# Access Compliance Report

## Public Rights-of-Way

Intersection ID: 31854	Main Street: NATIONS_FORD_RD	Cross Street: OLD_STONEBROOK_DR	Location: W
ADA ID: 36FE6F3B2342	Ramp Type: PerpDiag	Initial Pass/Fail: Fail	Overall Compliance: No
Severity Score: 31.25			
Codes/Mitigation Info/Possible Solution		Field Measurements/Component Compliance

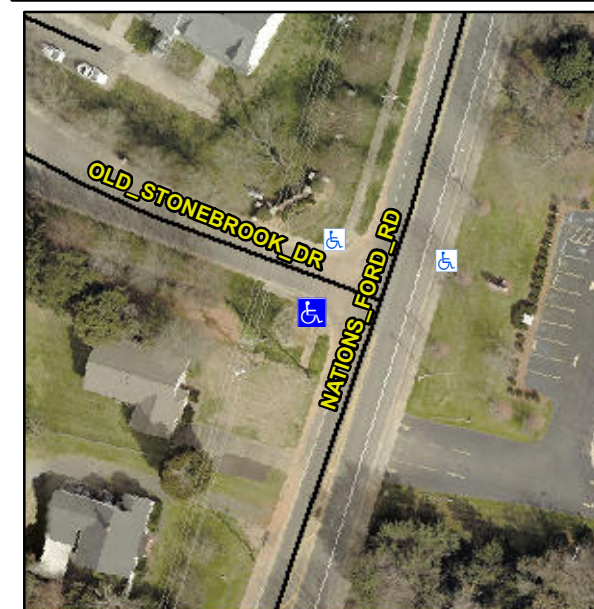
**Not Found, R304.5.1, R304.2.2, R304.5.3**

Compliance	Description	Data	Compliance	Description	Data
N/A	Ramp Length (in)	82.0	No	Ramp Slope (%)	10.1
No	Ramp Width (in)	34.0	No	Ramp XSlope (%)	3.2
N/A	Flare Type LT	N/A	N/A	Flare Type RT	N/A
N/A	Flare Slope LT (%)	N/A	N/A	Flare Slope RT (%)	N/A
N/A	Flare Traversable LT?	N/A	N/A	Flare Traversable RT?	N/A
N/A	Landing Length (in)	N/A	N/A	DWS Provided?	N/A
N/A	Landing Width (in)	N/A	N/A	DWS Contrast?	N/A
N/A	Landing Slope (%)	N/A	N/A	DWS Length (in)	N/A
N/A	Landing X Slope (%)	N/A	N/A	DWS Full Width?	N/A
N/A	Landing Curb? (Y/N)	N/A	N/A	DWS Offset (in)	N/A
N/A	Shared Landing?	N/A			
N/A	Gutter Ponding?	N/A	N/A	Gutter Slope (%)	N/A
N/A	Gutter Lip Ht (in)	N/A	N/A	Gutter X Slope (%)	N/A
N/A	Painted X Walk1?	No	N/A	Painted X Walk2?	No
	X Walk 1 Direction	To E		X Walk 2 Direction	To N
N/A	X Walk 1 Width (in)	N/A	N/A	X Walk 2 Width (in)	N/A
	X Walk 1 Slope (%)	3.3		X Walk 2 Slope (%)	0.1
	X Walk 1 X Slope (%)	1.9		X Walk 2 X Slope (%)	7.5

**Remove & Replace Curb Ramp With Two New Directional Ramps or Equivalent.**
